From: Sent: To: Cc: Subject: Attachments: Oswald, Hank Thursday, August 13, 2015 9:16 AM 'Guihua Wang' Timothy Wolfe; Williams, Jeffrey RE: 6801 Redberry Road A23170_P23177_6801 Redberry Lane.pdf

From: Oswald, Hank [mailto:hoswald@howardcountymd.gov]
Sent: Friday, August 07, 2015 4:26 PM
To: Guihua Wang; timothywolfe@kci.com
Subject: 6801 Redberry Road

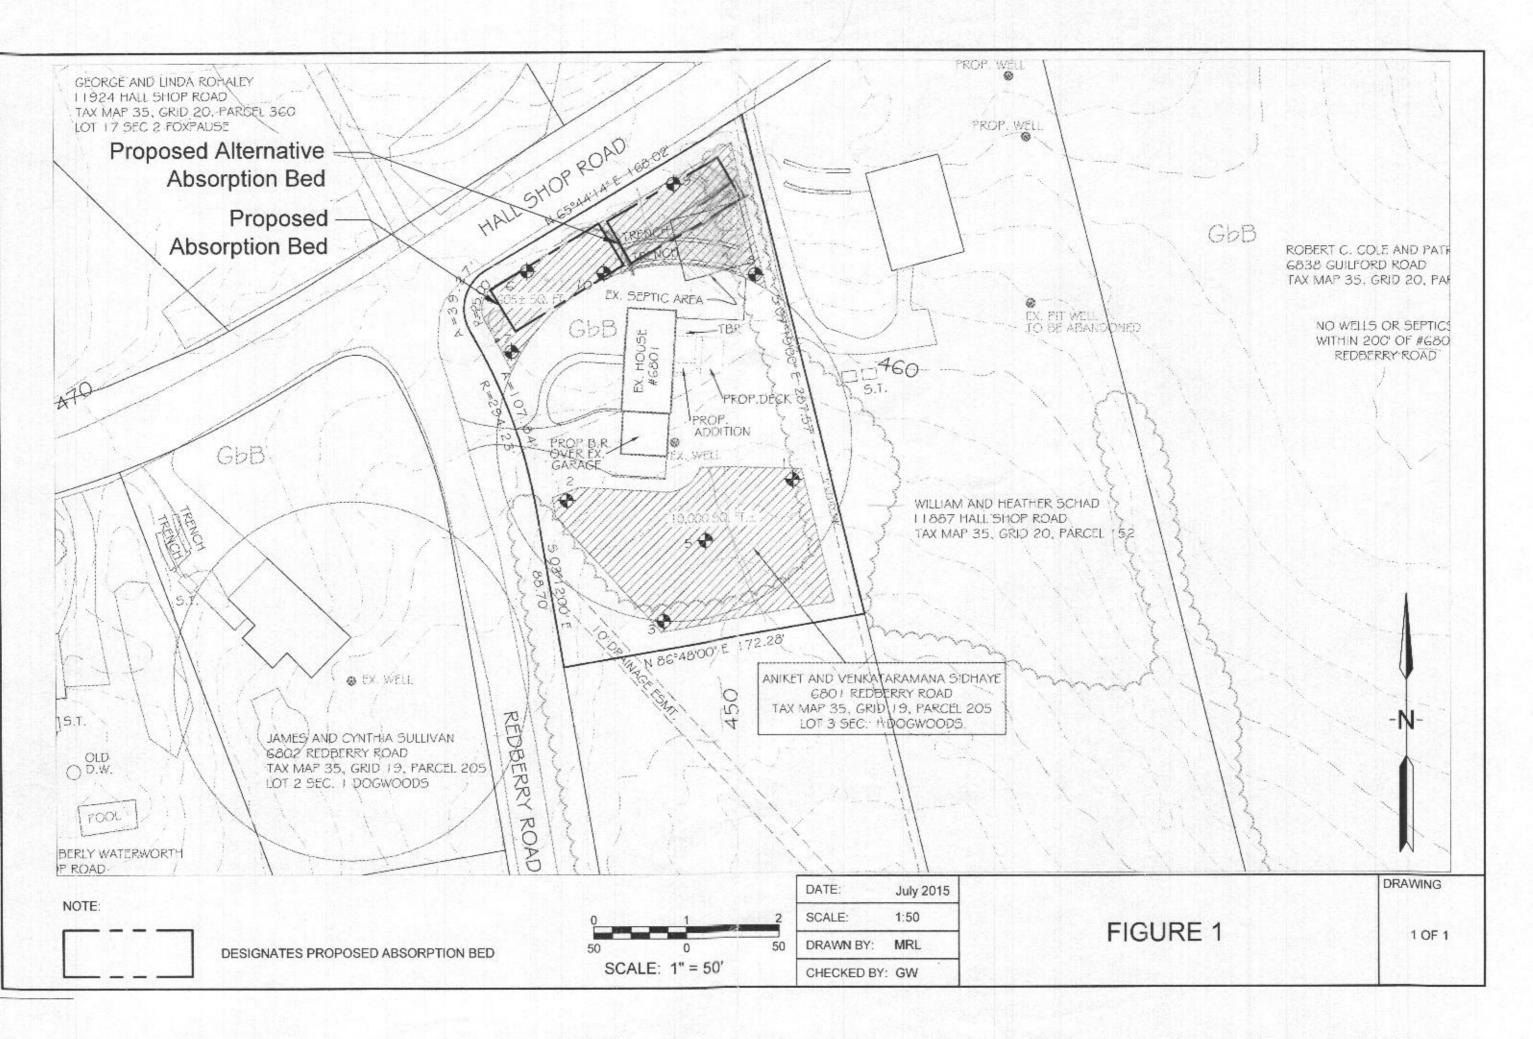
Today, I received a call from Fogle's Septic requesting a date to perform additional testing at Redberry Lane. Per our meeting on July 22, 2015, your company was supposed to field locate the existing septic system components (i.e. drywell and/or trench) using your ground radar equipment and figure out if the existing septic system meets the 4 foot buffer requirement

Prior to scheduling the next phase of testing, we will need to see this information on a revised plan showing the exact location of the existing septic system. If the system is not located in the proposed sand mound locations, and the existing septic system does not meet the 4 foot buffer requirement then we may proceed with At-Grade or Sand Mound testing.

Please note: it's extremely important to rope off the proposed sand mound areas so trucks and heavy equipment do not compact those areas and render unfit for a future system (while searching for the existing septic system). Should you need to extend your search into the proposed sand mound area, please use a probe.

Also, the Sand Mound calculations submitted for review shows a Bed Length of 80 feet but the length of the proposed sand Mound systems shown on the plan are only 65 feet.
